SERVICE BULLETIN

GL1500 #1
REVISED: MARCH 1988

PRODUCT UPDATE

1988 GL1500 CARBURETOR VENT HOSE ROUTING

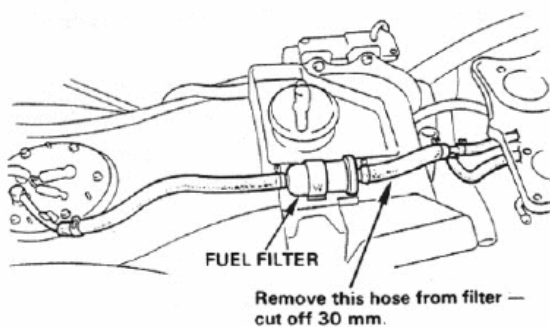
2. Locate the right and left carburetor vent hoses that connect into a T-fitting at the back of the air cleaner box. Measure and cut these hoses as follows:

— Remove both hoses from the T-fitting. Discard the fitting.

— Left and Right Hose: Measure back **120 mm** from the carburetor and cut both hoses at this point. Discard the cut hose pieces.

IMPORTANT: Be sure the length of each hose is 120 mm.

3. Remove the fuel hose from the carburetor side of the fuel filter. Measure and cut 30 mm off this hose.

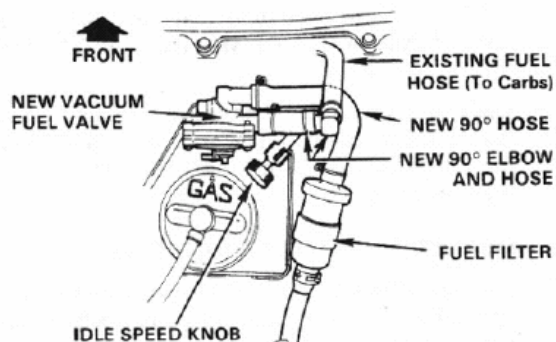
11. Install the new 90° fuel hose onto the fuel filter and attach the filter back onto its mounting tab. Connect the other end of the hose to the front fitting on the vacuum fuel valve. Position and secure the hose clips.

NOTE: The large end of the hose should be installed on the fuel valve.

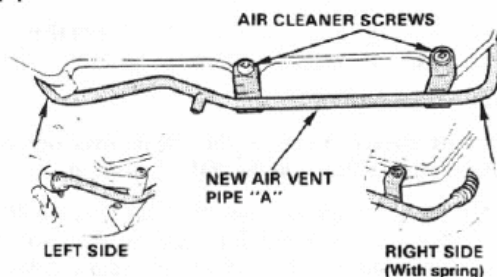
12. Slide the new spring over the right vent hose. Push both the vent hoses onto the new Air Vent Pipe "A" (push on 20 mm to the stopper). Remove the two rear air cleaner cover screws and mount the new vent pipe onto the air cleaner box.

- Check that both vent hoses are not pinched or kinked, especially where they bend around the air box.

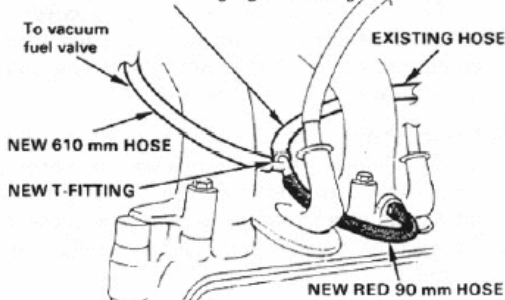
13. **49-STATE MODELS ONLY:** Remove the vacuum hose from the fitting on the right intake manifold, between #3 and #5 spark plug.

NOTE: For future carb. synch., remove this hose and connect vacuum gauge to T-fitting.

- Measure, cut and discard 100 mm from the end of this hose. Install the new T-fitting into this hose and attach the red vacuum hose back onto the manifold fitting. Position and secure the hose clips.

CARBURETOR SYNCHRONIZATION

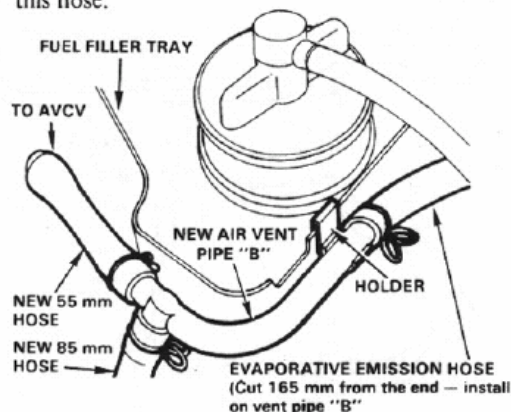
NOTE: The new vacuum fuel valve needs to remain connected for the bike to run. For future carburetor synchronization, leave the 610 mm hose and the red vacuum hose connected. Disconnect the remaining cruise control vacuum hose and attach the vacuum gauge at this fitting. (This does not apply to California models)

- Attach the new 610 mm vacuum hose to the center of the new T-fitting. Route this hose up inside the frame between the air cleaner box and the front of the fuel tank. Connect the end to the fitting on the vacuum fuel valve. Be sure the hose is not pinched or kinked. Position and secure the hose clips.

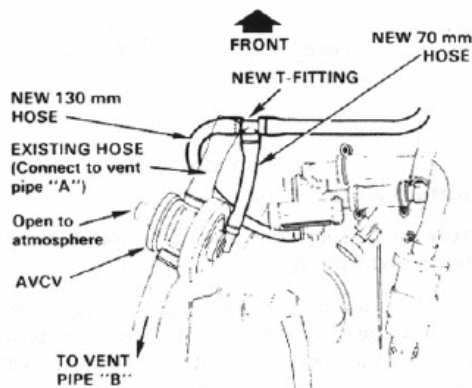
16. Measure, cut and discard 70 mm from the vacuum hose removed in step 6. Install the new T-fitting into this hose and connect the new 70 mm vacuum hose to the AVCV.

17. Attach the new 130 mm vacuum hose from the T-fitting to the vacuum fuel valve. Position the fuel valve hose clip downward.

18. Route the new T-fitting and vacuum hoses under Air Vent Pipe "A". Connect the existing AVCV hose to Air Vent Pipe "A". Mount the AVCV on its tab on the fuel filler tray.

CALIFORNIA MODEL

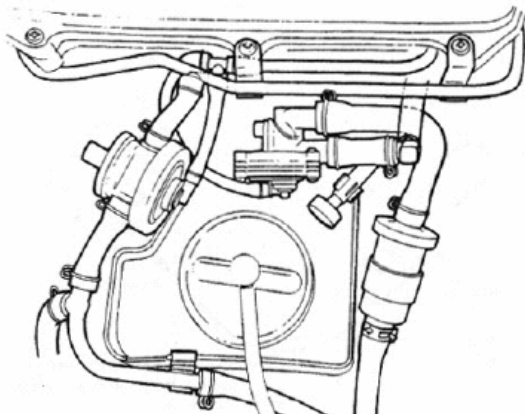
20. Confirm the installation and routing of all the new parts. Be sure the hoses are not pinched or kinked. Double-check that all hose clips are positioned and secured.
